Response to Referee#1

Response: We appreciate the reviewer for pointing this out. Taking this comment into consideration, we have revised the title as follow: “Design and Application of a Multi Hazard Risk Assessment Survey Questionnaire for the Indian Himalayan Region”. Replaced ‘testing’ with ‘application’.

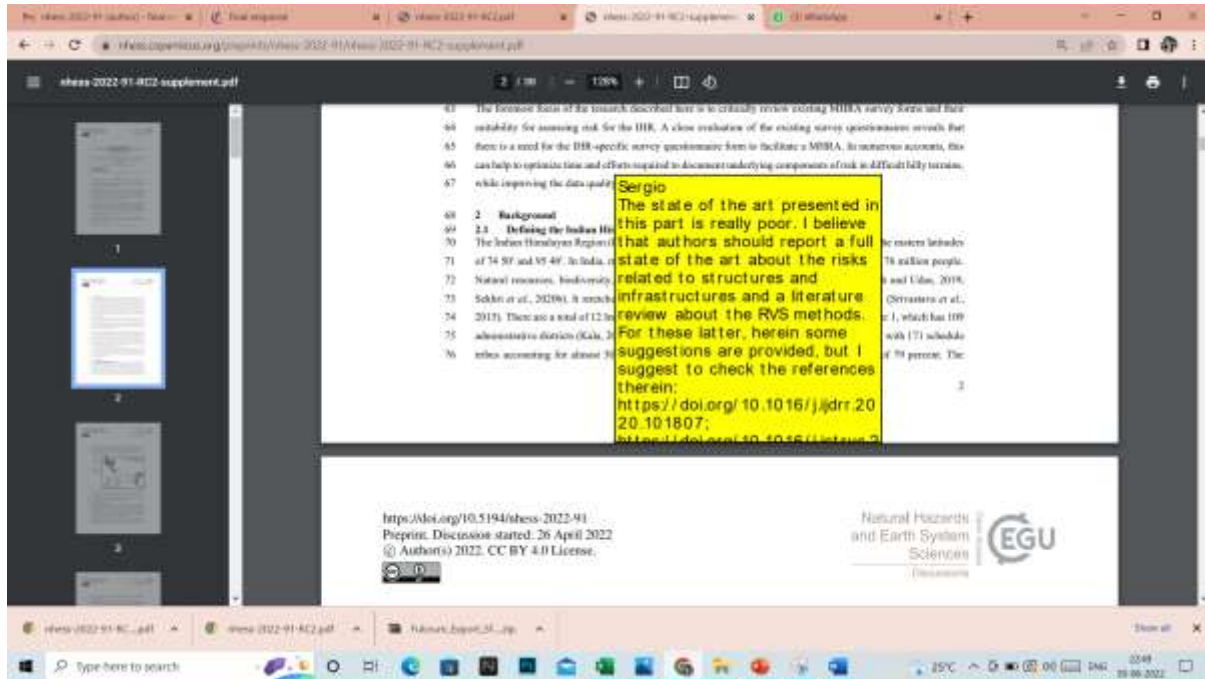
Comment (R1)-7: Authors have prepared a comprehensive multi-hazard form however; they have not indicated how the multi-hazard is computed.

Response: We appreciate the reviewer for highlighting this point and we agree that step wise detail of multi-hazard risk computation is not part of the manuscript, as scope of Risk Calculation study by itself is huge and we have plan to detail it in separate article. Taking this comment into consideration, we have updated basic Multi-Hazard Risk Computation in section 4.4 and added Results of Pilot Survey in section 4.5. This will improve clarity about risk computation using this proposed Survey form. The aim behind this manuscript is to design a Hill specific MHRA Survey form that simplifies data collection process with higher level of respondents' involvement.

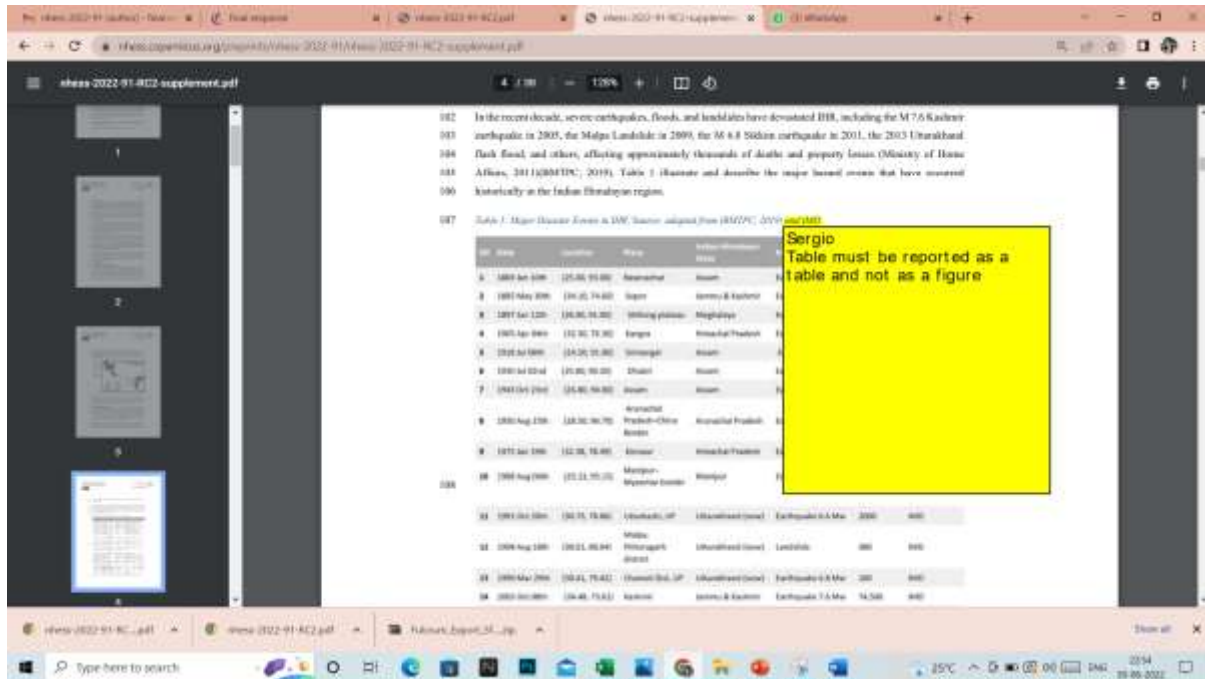
Comment (R2)-2: Please ensure high quality figure 1 to 5

Response: We thank the reviewer's for highlighting this point and accordingly, we have replaced all the figures (identified by referee-Figure 1 to 5) with high quality pixels. We will send the figures in separate files.

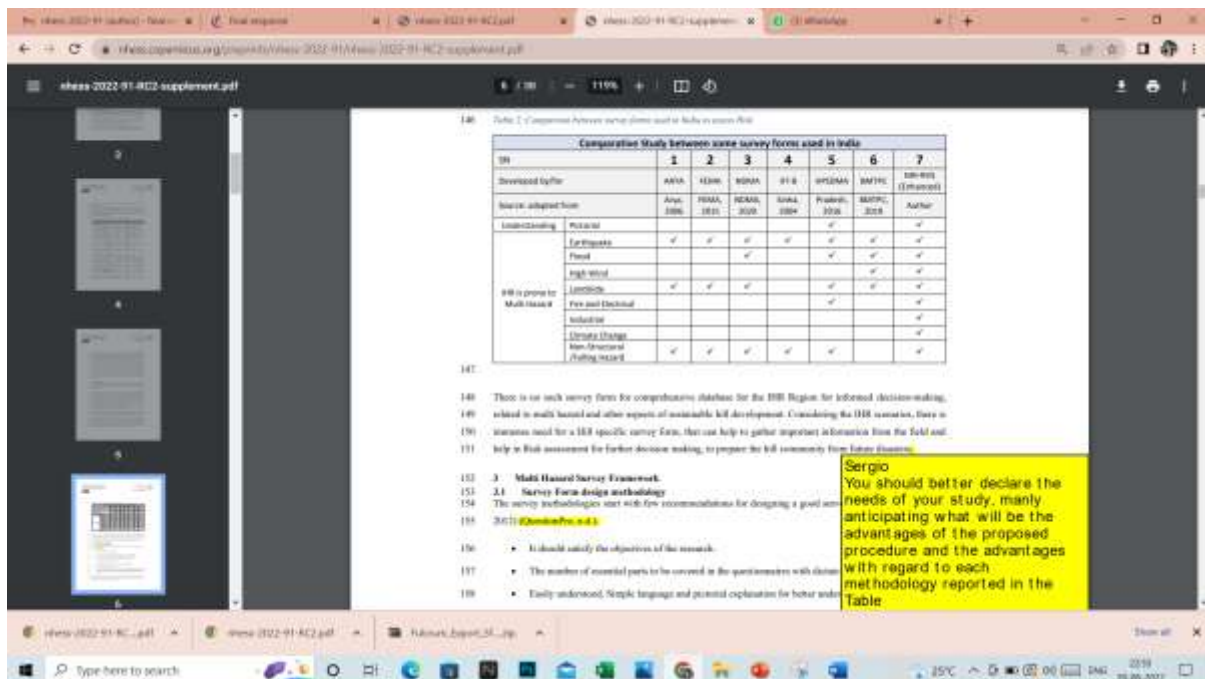
Comment (R2)-3: Table must be reported as a table and not as a figure

Response: We appreciate the reviewer’s insightful suggestion; accordingly, we have updated the Table 1.

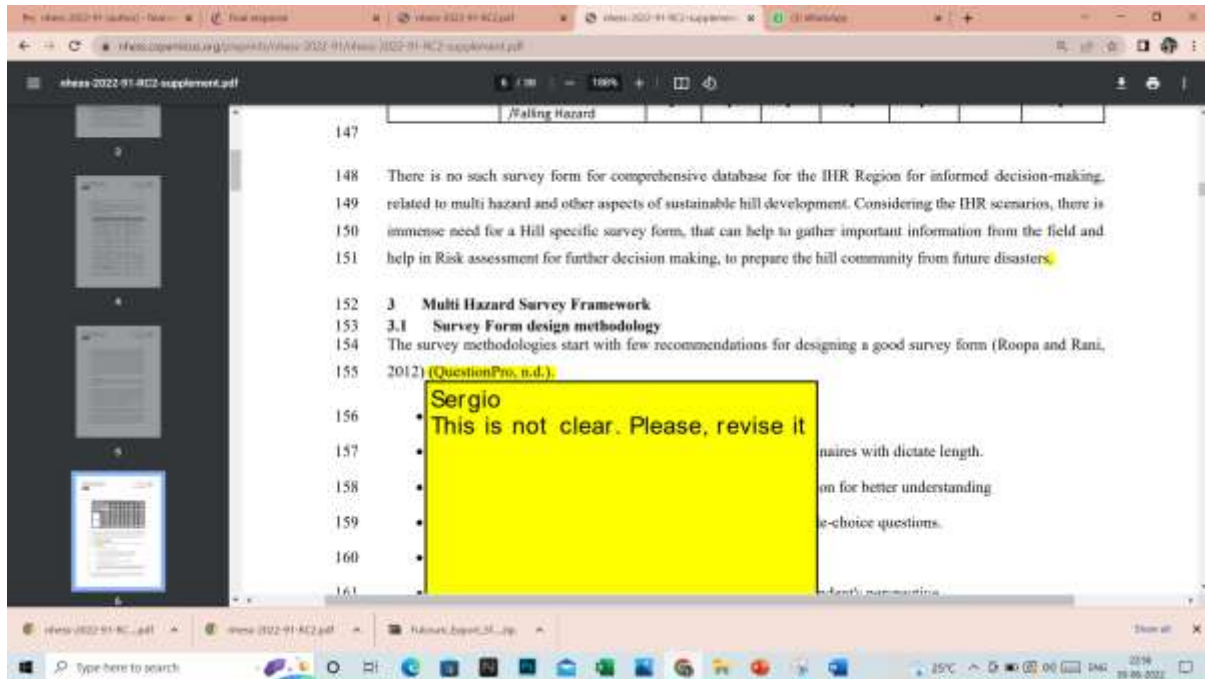
Comment (R2)-4: You should better declare the needs of your study, mainly anticipating what will be the advantages of the proposed procedure and with regard to each methodology reported in the table

Response: We have refined the need of the study in section 2.3. However, advantage of the proposed procedure is already mention in section 5.2 of the manuscript.

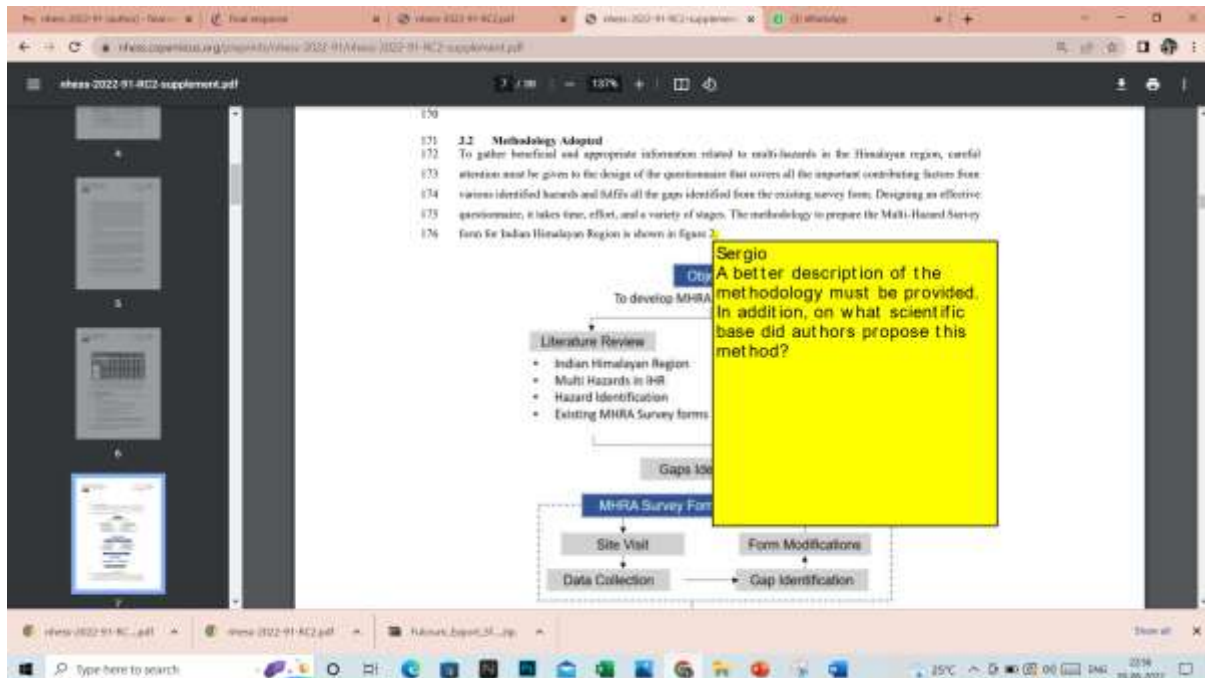
Comment (R2)-5: (QuestionPro, n.d.), is not clear. Please revise it.

Response: We have revised the design methodology in Section 3.1 and detailed the overall methodology adopted in section 3.2 and figure 2 of the manuscript for better clarity.

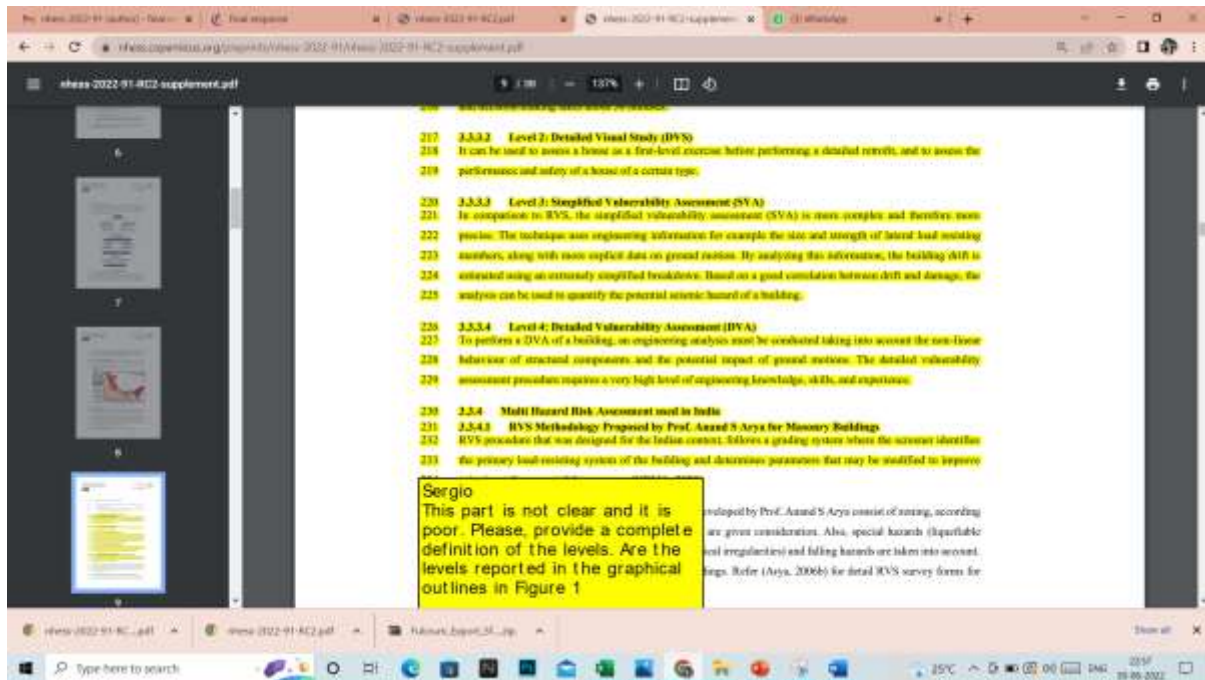
Comment (R2)-6: A better description of the methodology must be provided. In addition, on what scientific base did authors propose this method?

Response: We greatly appreciate the reviewer's thoughtful suggestion. Taking this comment into consideration, we have revised the methodology in section 3.2 and figure 2. We have also detailed it for better understanding and clarity on the overall methodology adoption.

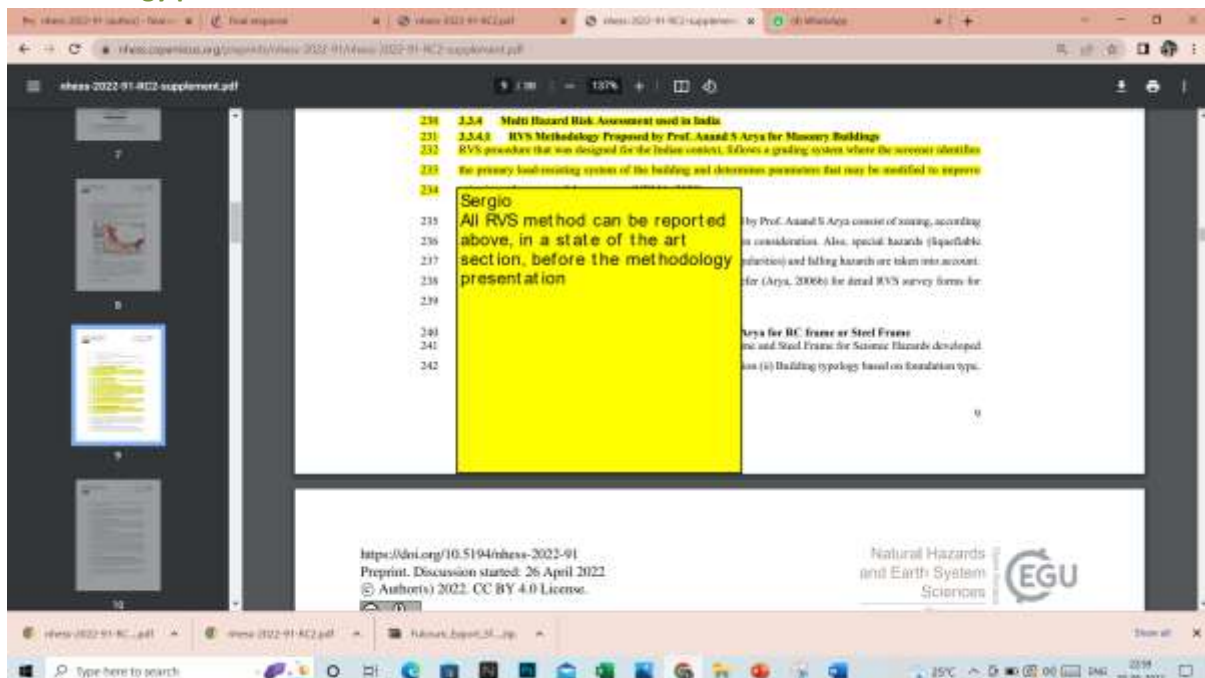
Comment (R2)-7: This part (3.3.3) is not clear and it is poor. Please provide a complete definition of the levels. Are the levels reported in the graphical outlines in Fig1

Response: We have revised the section 3.3.3 and incorporated it in the methodology figure 2.

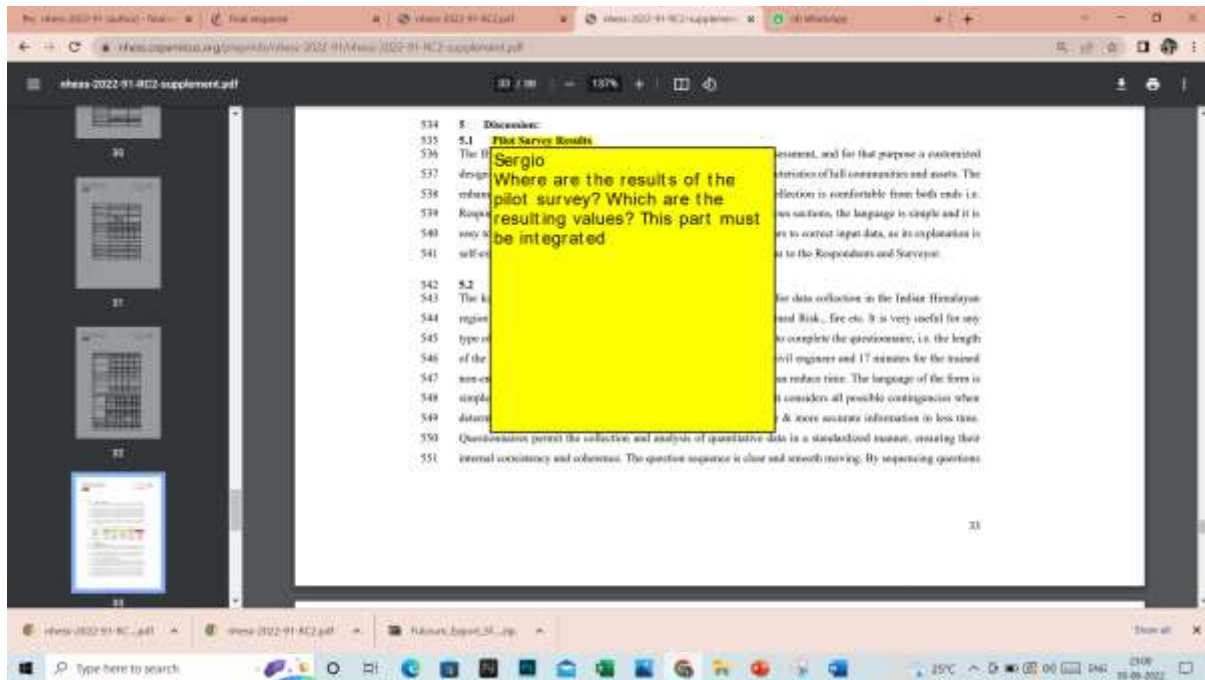
Comment (R2)-8: All RVS method can be reported above, in a state-of-the-art section, before the methodology presentation.

Response: We appreciate the reviewer's thoughtful suggestion. However, considering the structure of the manuscript, after a thorough discussion, we are continuing the flow of the structure as before, i.e. to combine all information related to literature reviews in section 3.3 of the manuscript, including information about RVS.

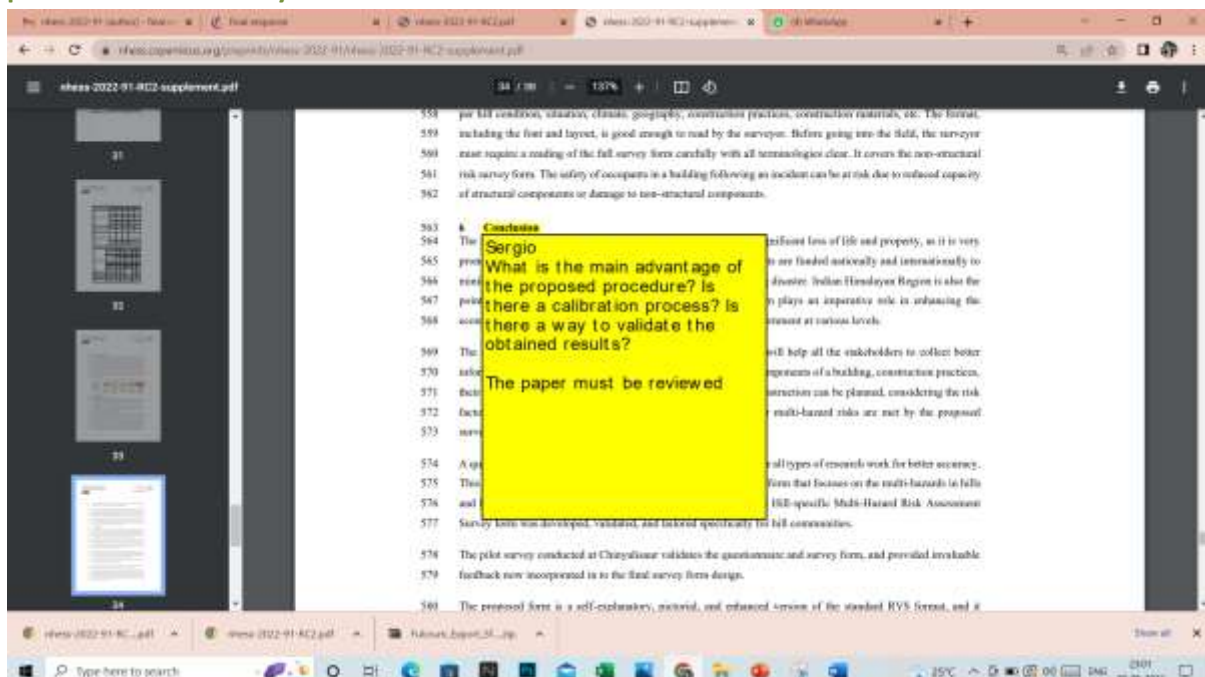
Comment (R2)-9: Where are the results of the pilot survey? Which are the resulting values? This part must be integrated

Response: We greatly appreciate the reviewer's thoughtful suggestion (which will definitely enhance our work) and we agree with it. Taking this comment into consideration, we have added Pilot Survey of 10 schools and its results in section 4.5 and discussion about its result in section 5.3 of the manuscript.
